# HISTORIC AND DESIGN REVIEW COMMISSION December 04, 2019

**HDRC CASE NO:** 2019-676

**ADDRESS:** 1023 N PINE ST

**TYPE OF WORK:** Shade structure, solar panels, mural

FOUNDATION PLAN, ROOF FRAMING PLAN,

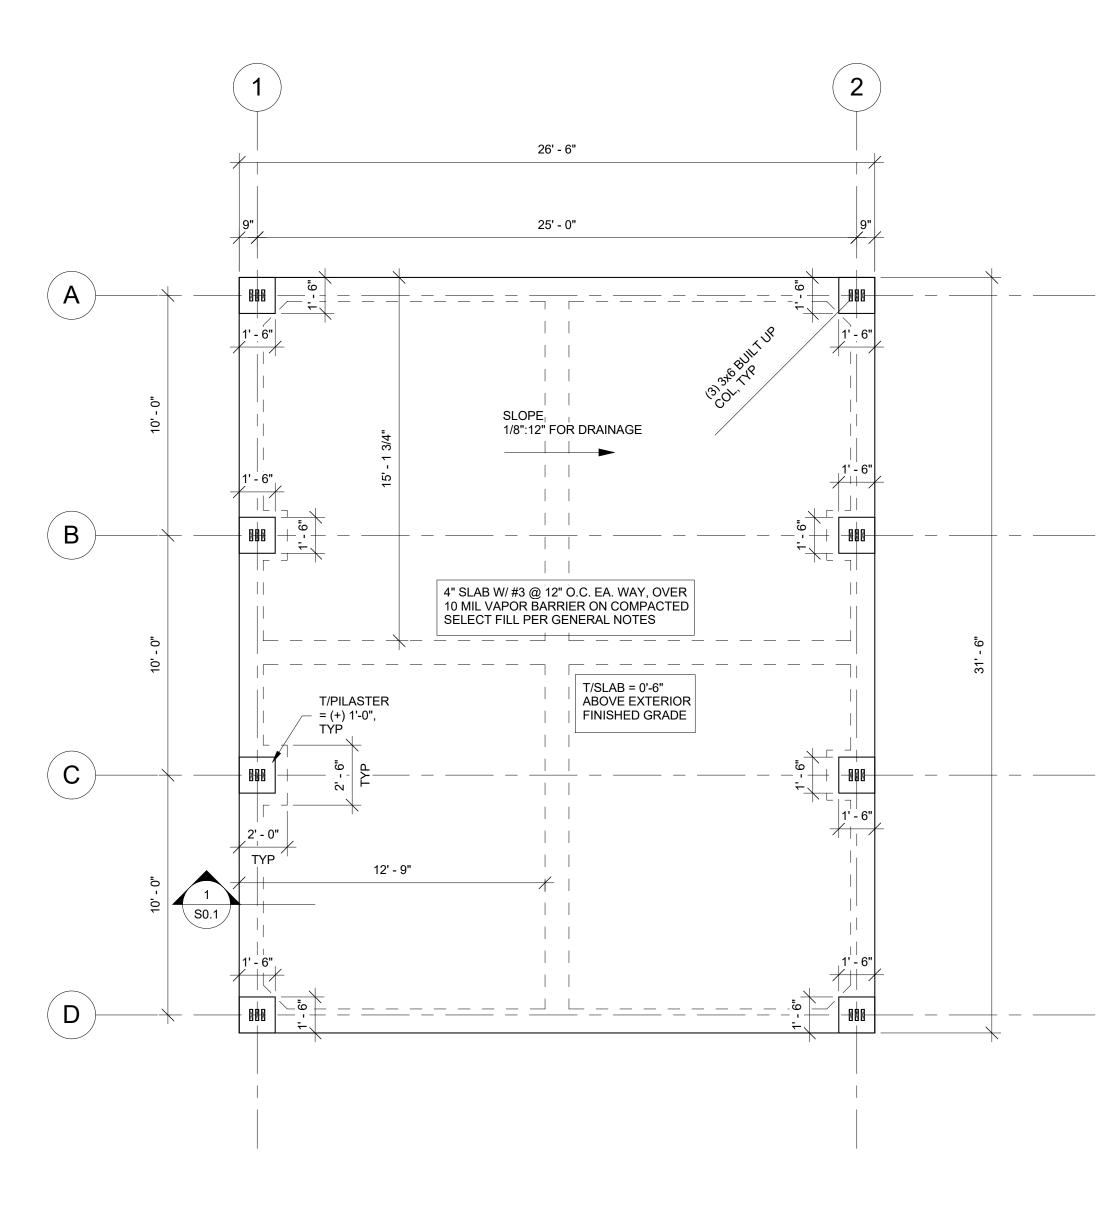
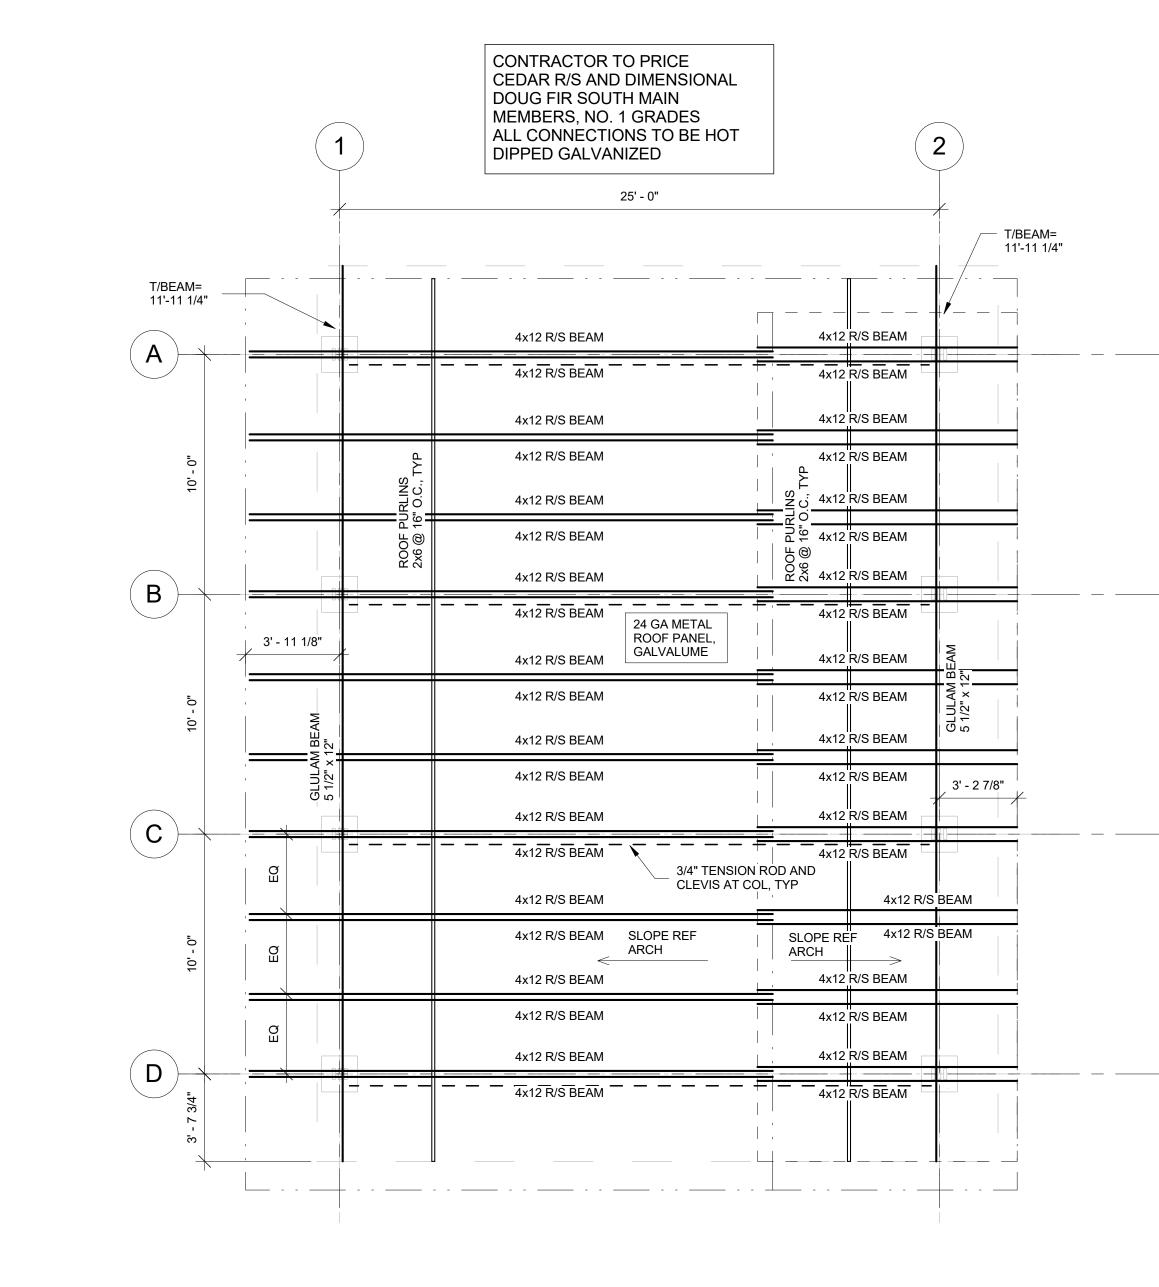
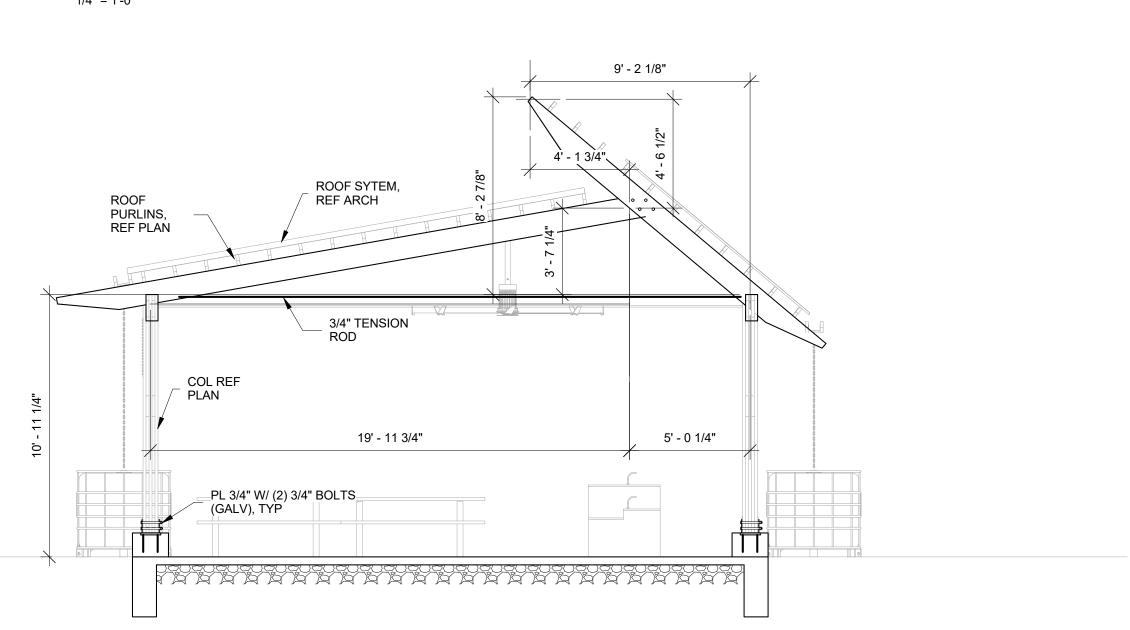
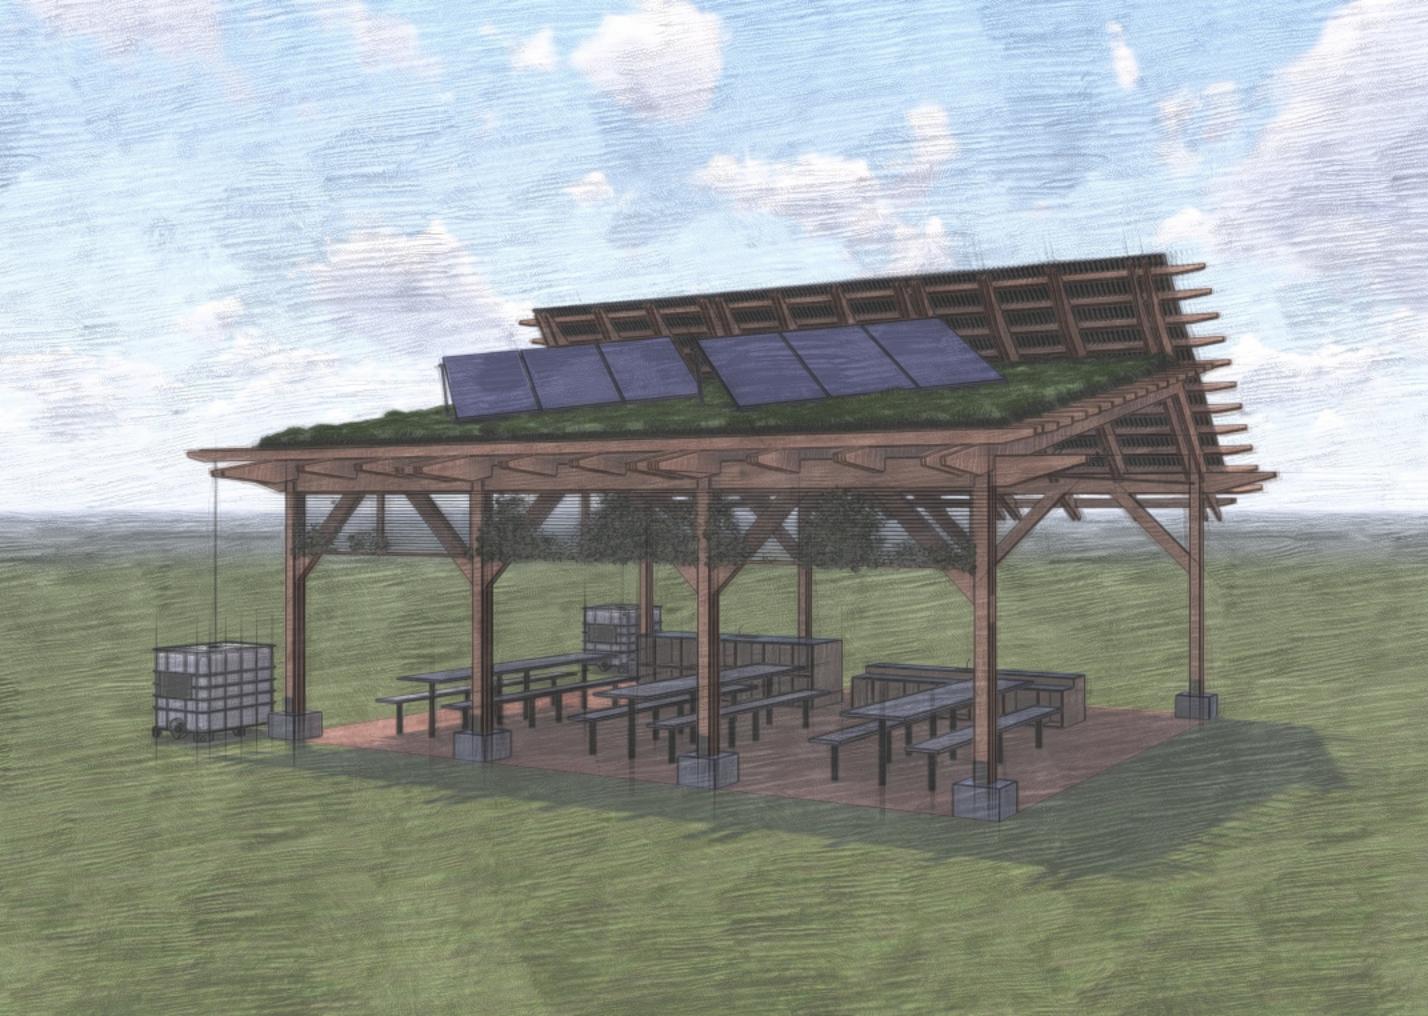
- b. The applicant has proposed to install 1,206 square foot shade structure at the Youth Garden to operate as an Educational Outdoor Learning Center (EOLC). The site will feature flagstone pavers with a crushed gravel base, 8 wood post columns with concrete bases, skillion and lean-to metal roof with solar panels, tables, storage, and 2 cisterns.

- c. MASSING AND FORM The applicant has proposed to install a 1,206 square foot shade structure featuring a skillion and lean-to roof form. The structure is substantially subordinate to the primary historic structure and is generally consistent with the Guidelines for New Construction 5.A.i through iii.

- e. SOLAR COLLECTORS The applicant has proposed to install solar collectors on both slopes of the skillion and lean-to roof. The solar collectors will feature a layer of special film depicting artwork related to Ella Austin. Staff finds the solar collectors with added artwork are generally consistent the Guidelines for New Construction 7.C.ii.

Staff recommends approval based on findings b through e.
